Access Compliance Report

Public Rights-of-Way

(Pedestrian Signals)

Intersection ID: N/A	Main Street:	Cross Street: N/A	Location: N/A
ADA ID: E16A47C6A571	Signal Type: One Push Button-Non APS	Overall Compliance: No	Severity Score: BTN 1: N/A BTN 2: N/A No BTN: N/A
Codes/Mitigation Info/Possible Solution		Field Measurements/Component Compliance

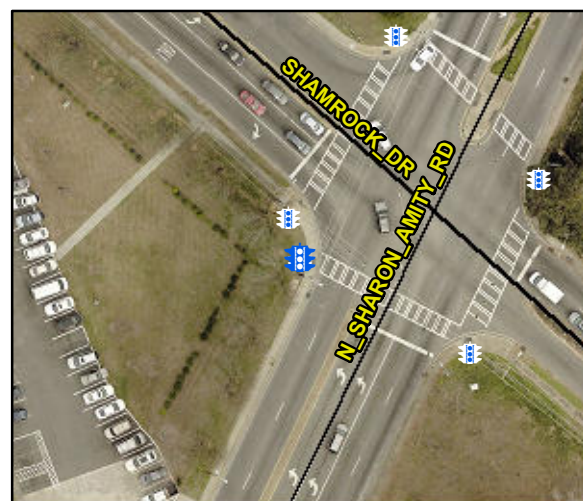
Surveyor Notes: UPDATED FWRD APPRCH AS SAME AS PARA APPR

PROW/ADA: TMUTCD 4e.08, R404.2, R404.3, R406.2

Possible Solutions: Replace Signal Push Button With APS Button on New Post. Remove & Relocate Sign.
